DOC #	PROCESS NAME	PAGE	REVISION	STATION	BY	DATE
<b>AR841</b>	Replace Dedicated Micro Box Bracket	1 OF 1		SER-E	C.WARD	6/23/2017

**Complaint:** Dedicated Micros Box Bracket cracking

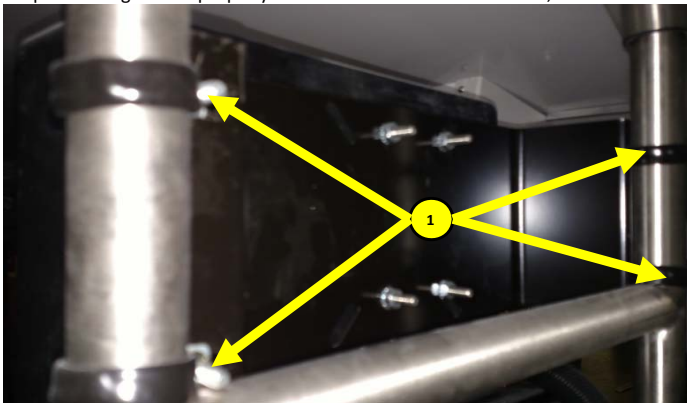
**Cause:** Bracket 1309054 does not have enough material between slotted hole and exterior edge of part

**Correction:** Replace Bracket 1309054 with revised Bracket 1310546

1310546 Bracket, TV Mounting Plate 14GA Black
